Certificate of Appropriateness

1943-45 N. 2ND ST. Brewers Hill Historic District

PTS ID 93331 COA, exterior repairs front and rear houses

Main House
Siding Repair – Damaged siding being replaced per spec

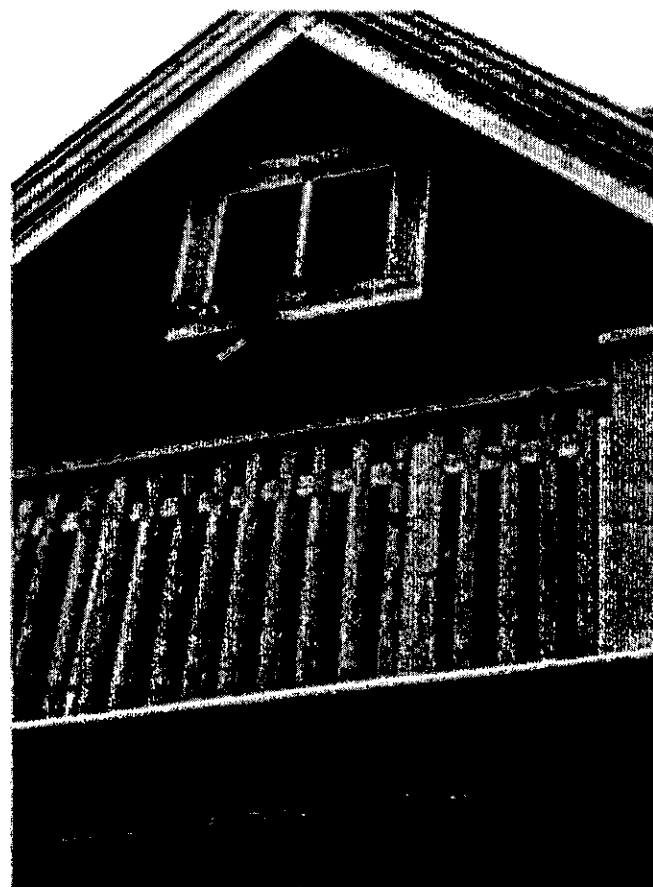
Replace missing and damaged siding on front house as needed with new, clear (no knots) radially-sawn wood clapboards.
